971 Richmond Road, Marsden Park

ISSUE E - AMENDMENTS - 15.07.21

DEVELOPMENT APPLICATION

Proposed Mixed Use Development

1 Subdivision Plan
Overall 1 : 1500 @A3

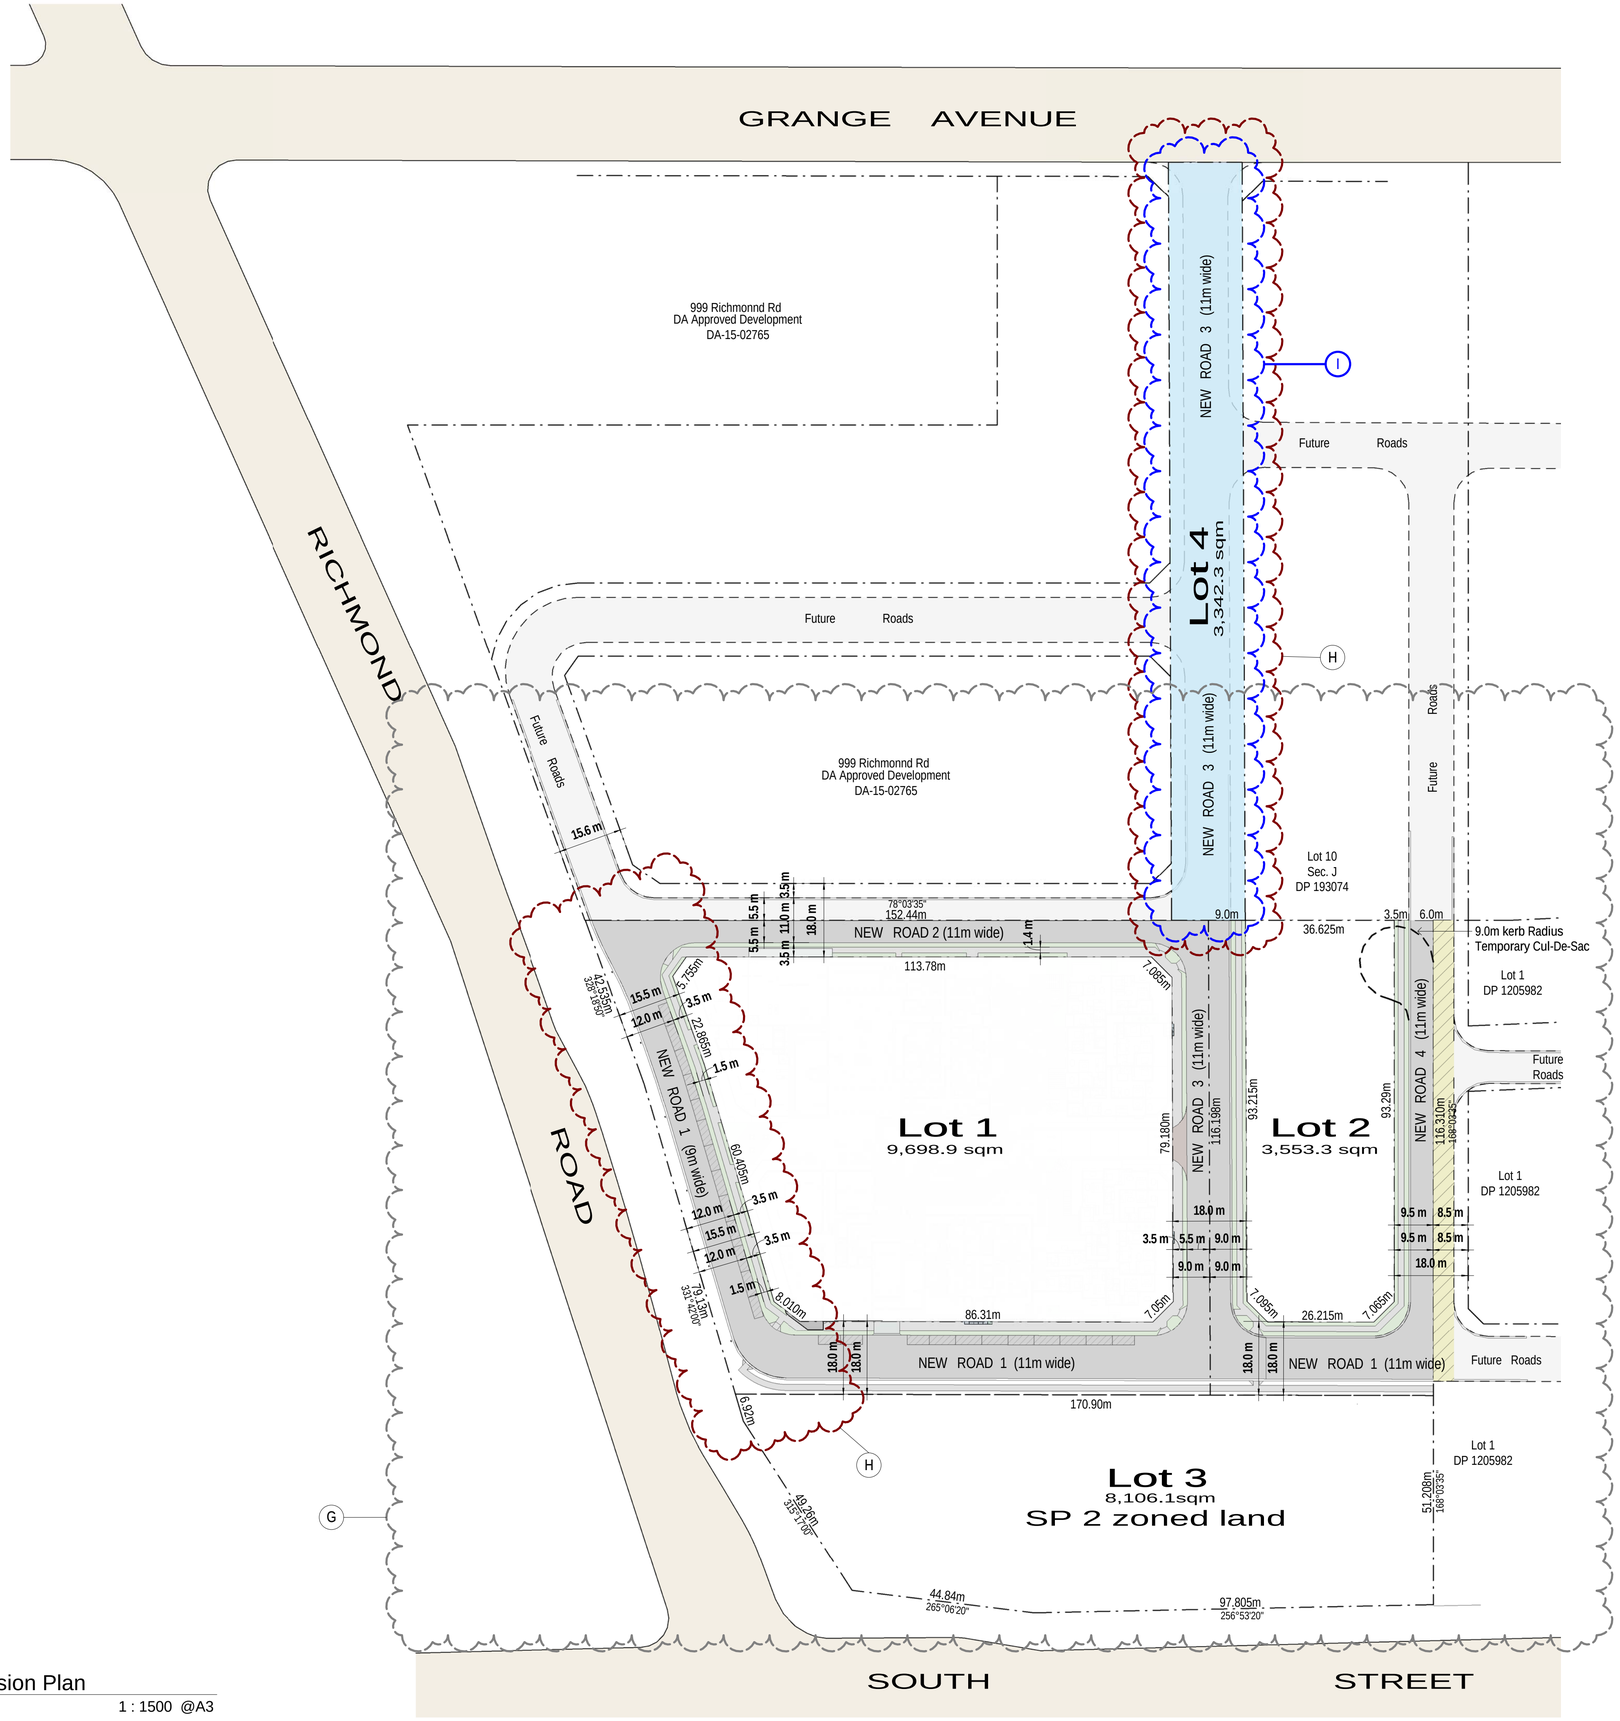
ISSUE G - AMENDMENTS - 02.06.21
1. R3 land (Lot 2) proposed as one super-lot 2. New road 1 & new road 3 amended to allign with adjoining da approved development. 3. SP2 boundary revised. Southern boundary alignments adjusted to suit 4. Lot 1 & Lot 2 boundaries amended 5. New Road 4 increased in width 6. 9.0m radius Temporary cul-de-sac provided
ISSUE H - AMENDMENTS - 29.06.21
1. New Road 1, along western boundary has been amended to incorporate a 3 metre wide landscaped area, resulting in New Road 1 in this area to be reduced to 9 metres wide. 2. New Road 3 / Lot 4 location & details added
ISSUE I - AMENDMENTS - 15.07.21
1. Lot 4 enlarged to include road reserves either side of New Road 3

1 Future Roads - Site Plan 1 : 1000

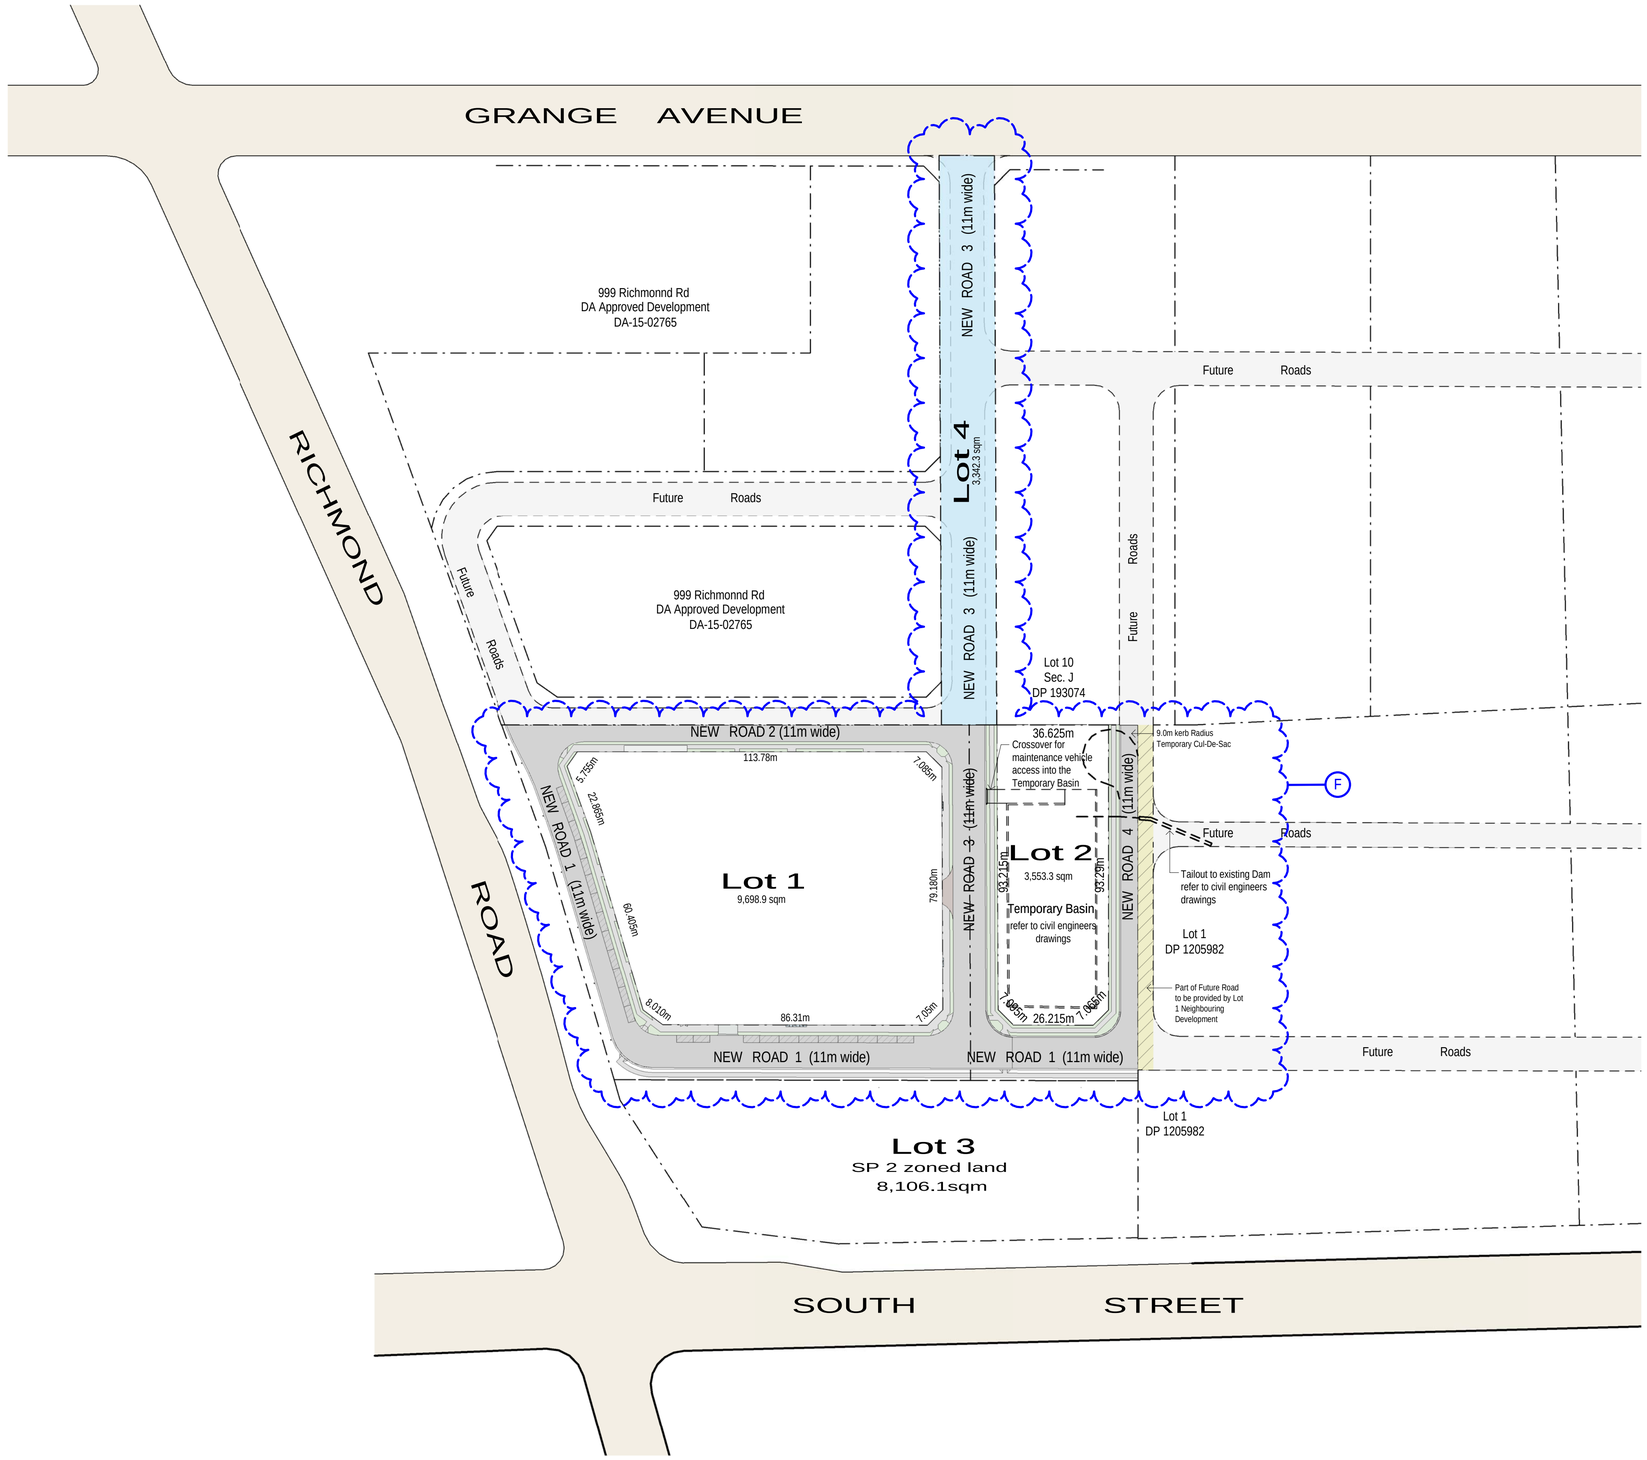
1. New Road 3 extended to Grange Road to form Lot 4.
2. New Road 1 reduced to 9m to allow for a 3m wide landscape strip adjacent to the Western Boundary.
3. R3 land (Lot 2) proposed as one super-lot
4. New road 1 & new road 3 amended to allign with adjoining da approved development.
5. SP2 boundary revised. Southern boundary alignments adjusted to suit
6. Lot 1 & Lot 2 boundaries amended
7. New Road 4 increased in width
8. Temporary Basin added to Lot 2.

1 Lot 1 - Staging Plan

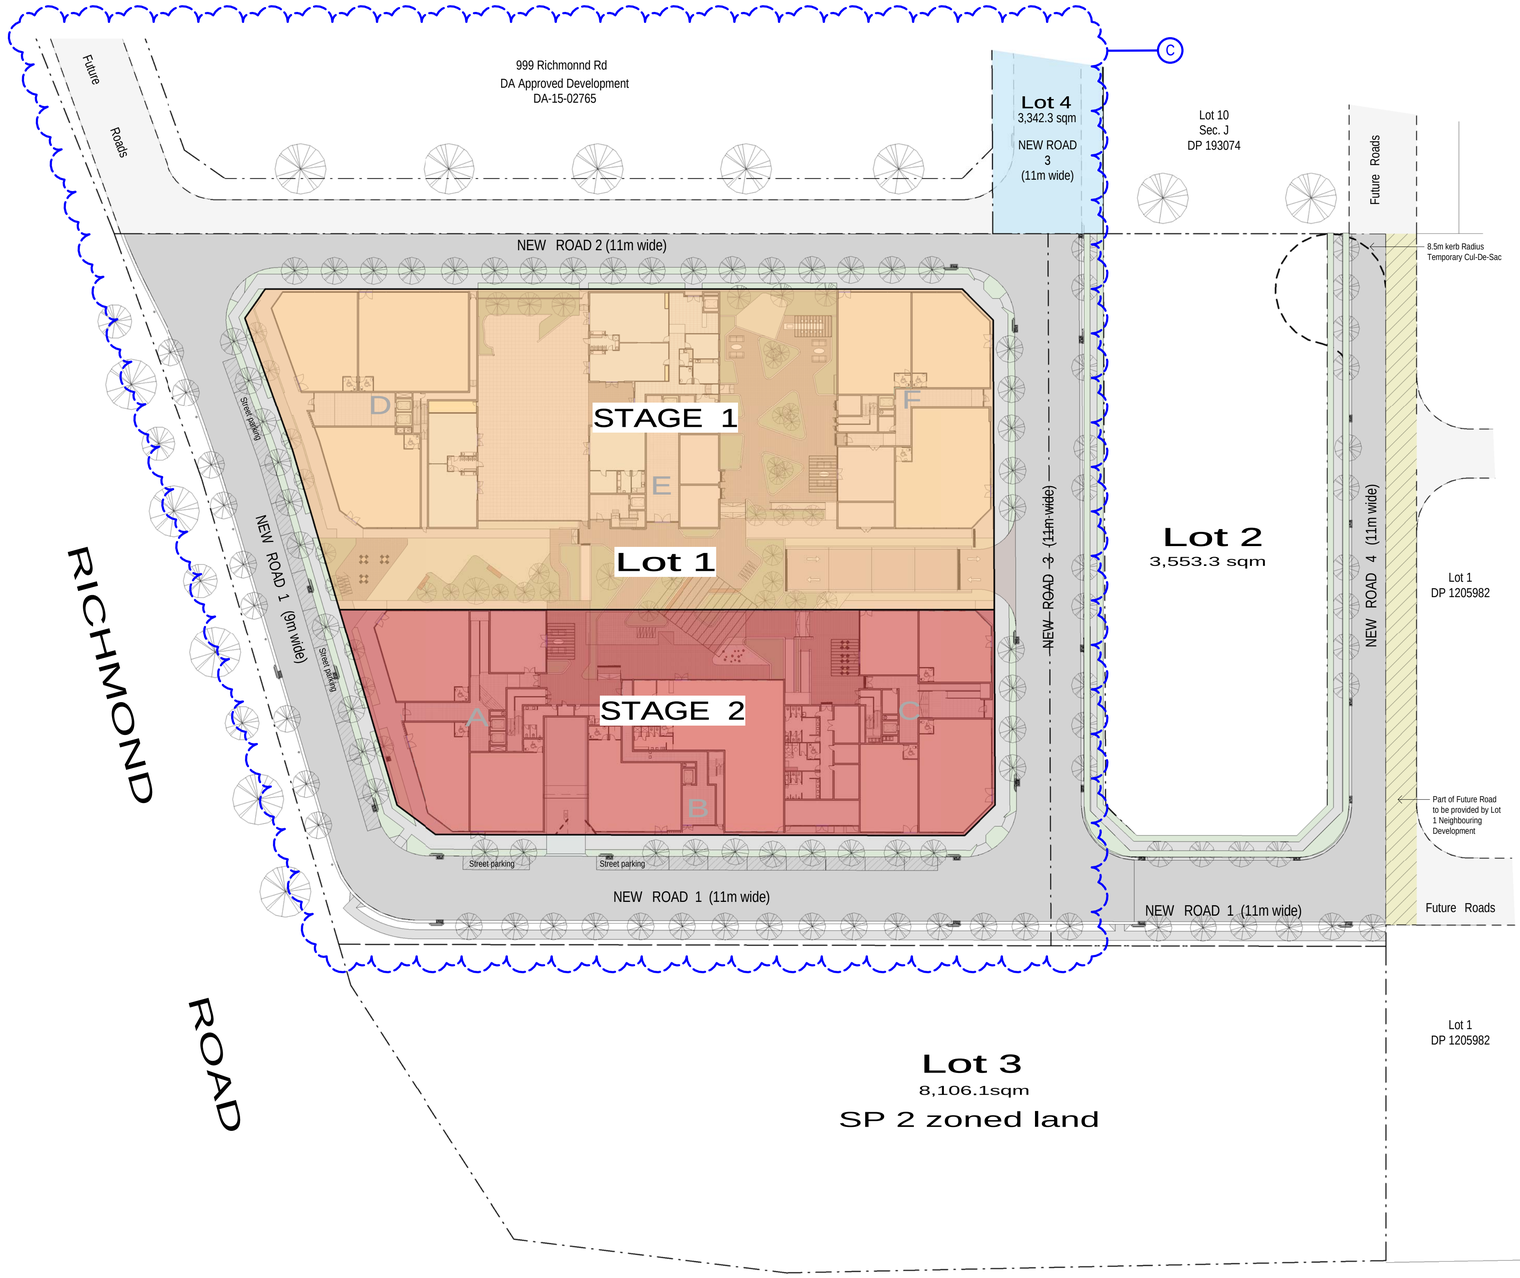
1. Staging Plan updated to match Subdivision Plan and Site Plans.

1 Overall Site Plan
1 : 1000 @A3

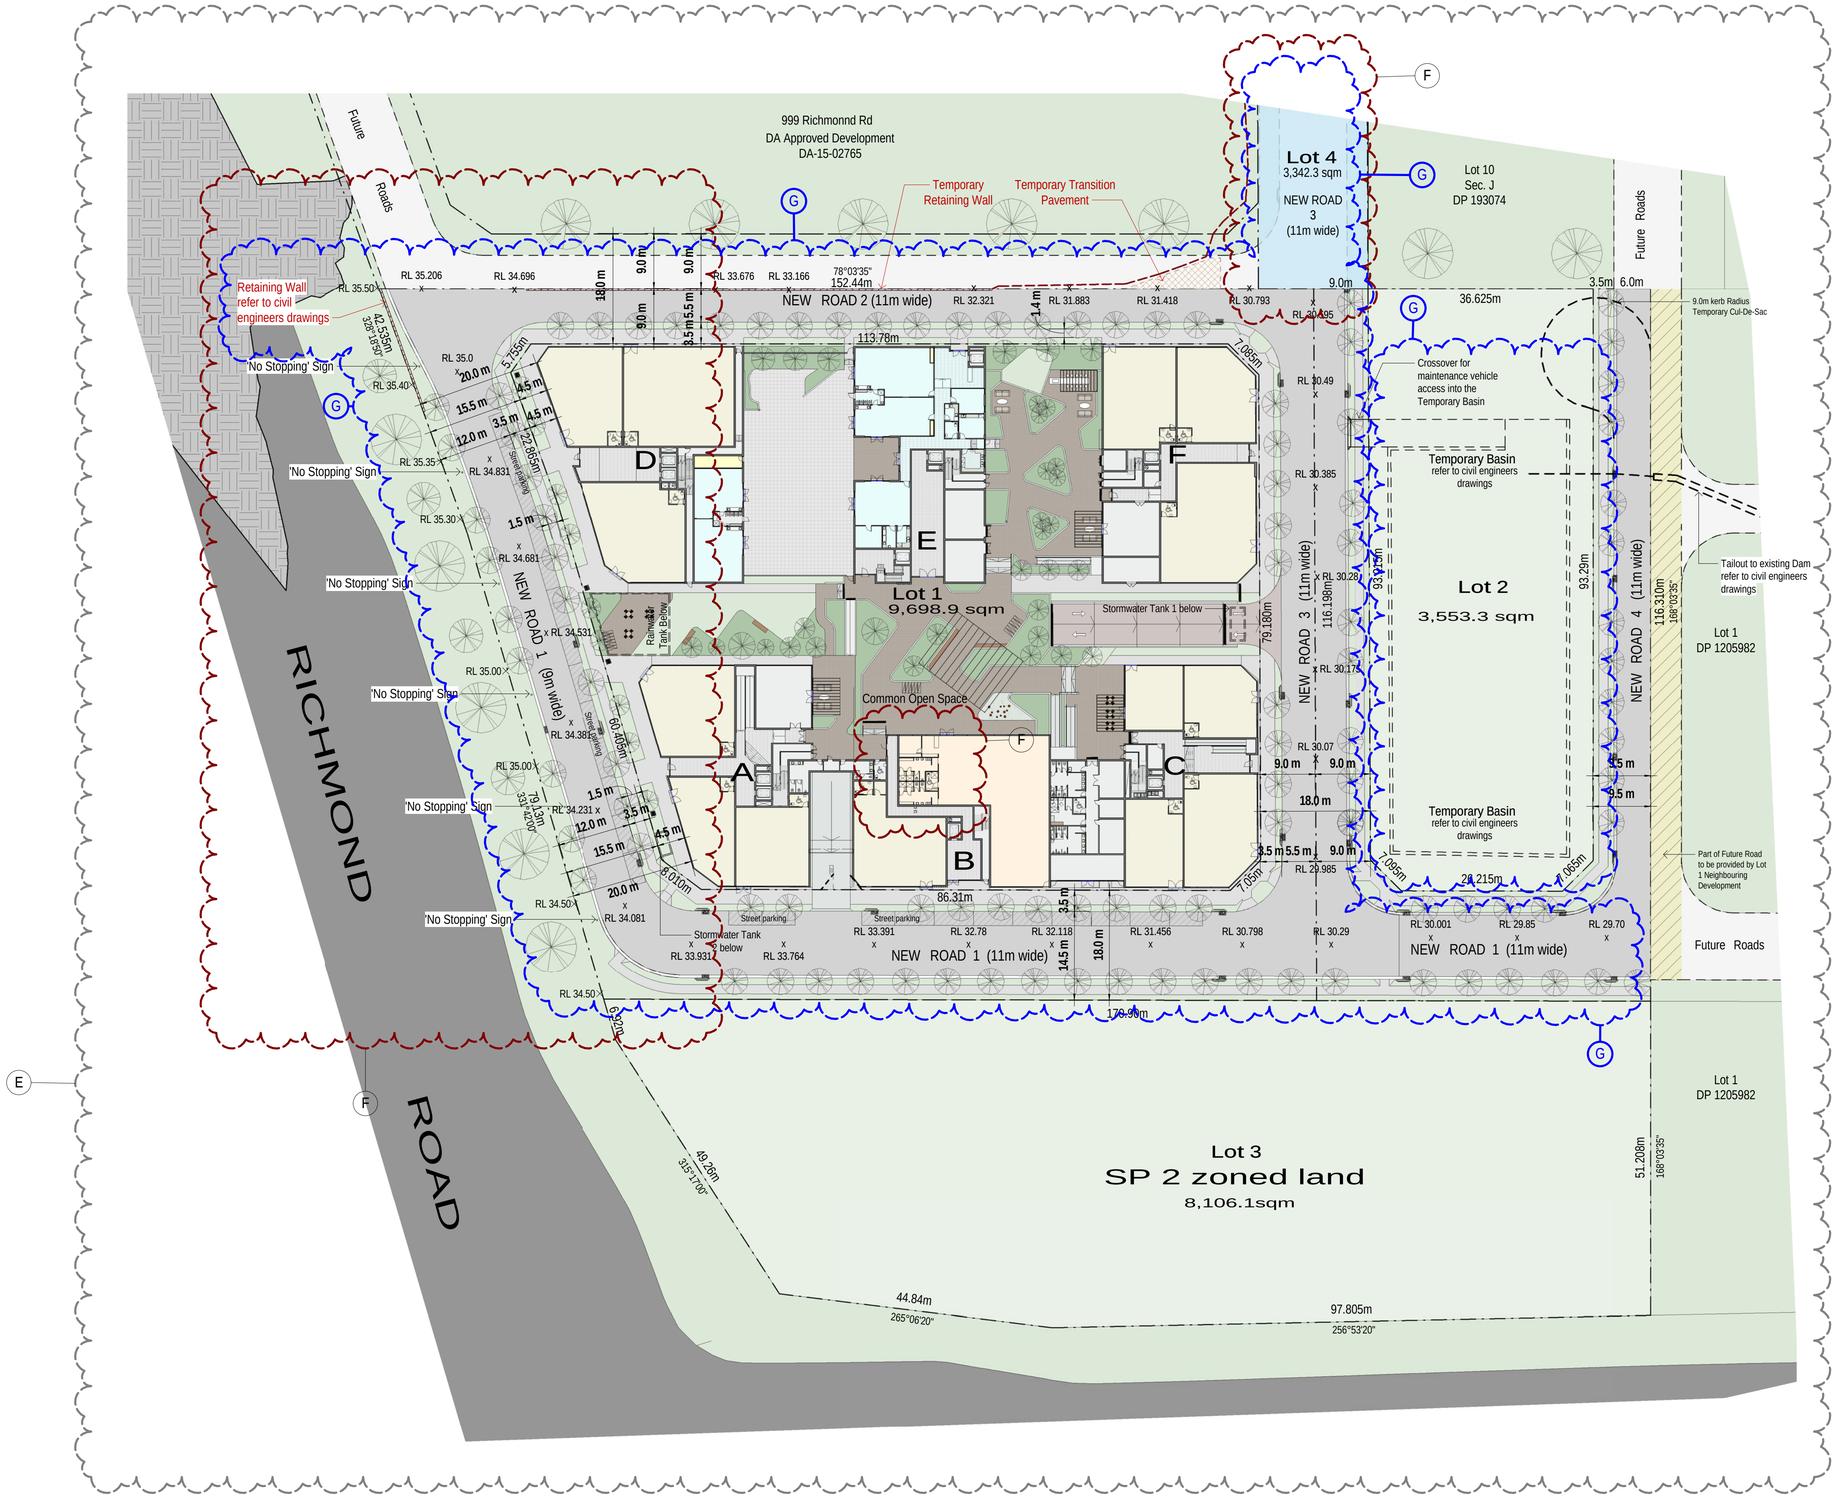
1. R3 land (Lot 2) proposed as one super-lot
2. New road 1 & new road 3 amended to allign with adjoining da approved development.
3. SP2 boundary revised. Southern boundary alignments adjusted to suit
4. Lot 1 & Lot 2 boundaries amended
5. New Road 4 increased in width
6. 9.0m radius Temporary cul-de-sac provided
7. Service Road deleted. Ramp access to northern basement relocated off New Road 3
8. Building Setback 20m from Richmond Road
9. Soft and hard landscape areas revised
10. Building footprints & internal layouts amended

1. New Road 1, along western boundary has been amended to incorporate a 3 metre wide landscaped area, resulting in New Road 1 in this area to be reduced to 9 metres wide.
2. New Road 3 / Lot 4 location & details added
3. Access to Building B Lobby added
4. 'No Stopping' signs added along New Road 1

1. Lot 4 enlarged to include road reserves either side of New Road 3.
2. Temporary Basin added to Lot 2.
3. Road RLs extracted from revised Civil Plans.
4. Path adjacent to Southern Boundary added.
5. Retaining walls added.
